## Planning Services

### Submissions Report

| <b>Sydney Eastern City Planning Panel</b> | PP_2017_IWEST_018_00  |
| <b>Address</b>                            | 469-483 Balmain Road, Lilyfield<br>Lot 2 DP 101583  |

Figure 6: Concept plan.

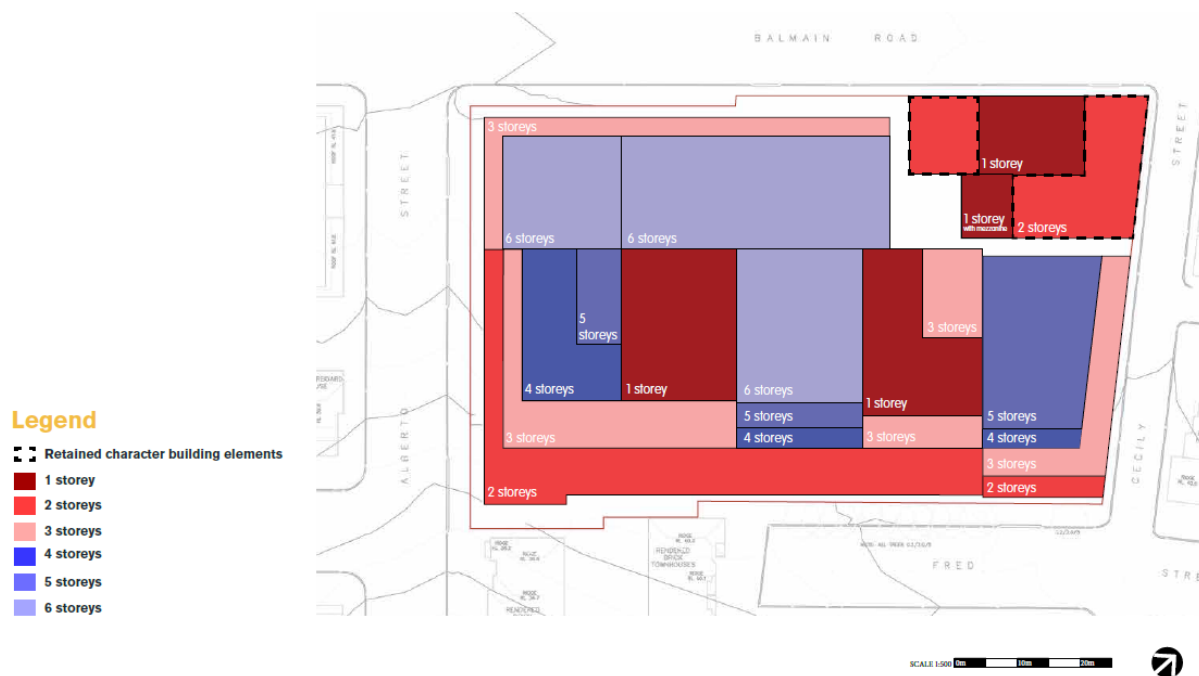
Some concern is raised that the visualisations provided in the planning proposal that demonstrate the concept height and scale to be deceptive Comments have been provided claiming that the illustrations mislead the visual impacts by excluding upper stories in some circumstances.

- Council considers that to minimise overlooking, a site specific LEP clause is needed that restricts the building heights at the sites perimeter to the equivalent of two residential storeys, with any higher building well set back (e.g. within a 22.5 degree height plane).

A contributing factor to the perceived bulk of the development is the maximisation of light industrial gross floor area (GFA) at ground level. The scheme utilises the benefits of site coverage allocated to a light industrial zoning whilst also introducing a substantial amount of additional floor space not currently permissible in the zone. This results in mass ground floor cover of the site and creates deep floor plates that minimises deep soil planting opportunities.

The Department questions this design strategy and the subsequent outcomes which does not lend itself to the most adaptable or attractive environment. The proponent has been provided with an opportunity to justify the overall built form of the site and how it will successfully function with both residential and industrial uses.

| Issue   | Proponent response   |
|---|--|
| <p>In response to concerns raised in the submissions regarding the concept visualisations</p> | <p>Roberts Day state that they consider the documentation submitted to exceed the requirements for planning proposals regarding visual communication.</p> <p>They further state that they consider that the images accurately depict the proposal and note that 3D files were issued to Government for verification.</p>   |

Figure 8: Concept section.

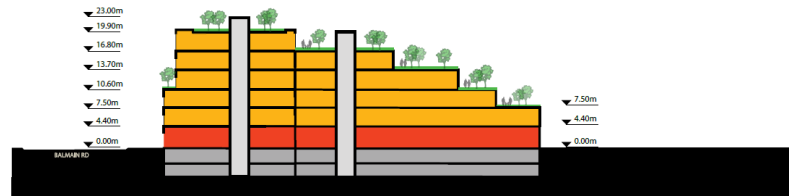
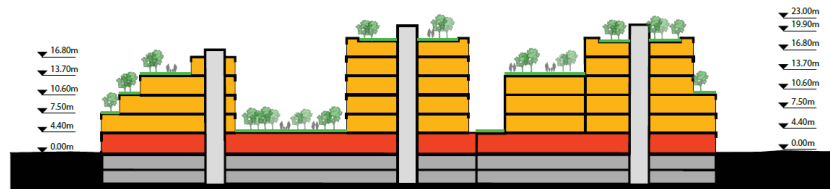
One submitter considered that the ground floor ceiling height put forward in the concept scheme of 4m to be inappropriate. The submitter considered that ground floor ceiling heights must be 6m internally to adequately support industrial businesses. The submitter explained that they considered this height is required to accommodate truck and container deliveries and to provide for the efficient use of the space with pallet racking etc. They stated that the 6m height would allow:

In their response to submissions Council concurred with the above outlined public submission's statement that there is a need to provide greater floor to ceiling heights for the industrial uses than indicated on the concept scheme. Council stated that this is required if the space is to be flexible and adaptable to a wide range of uses.

The proponent states that it considers the proposal provides generous ground floor, floor-to-ceiling heights appropriate for light industrial, particularly creative industries. They state that the Roberts Day Urban Design Report indicates a typical height of 4.4m for the new buildings and 5.2m for the character buildings. The proponent considers that these heights provide flexibility for future uses in addition to the opportunity for appropriate acoustic attenuation between uses.
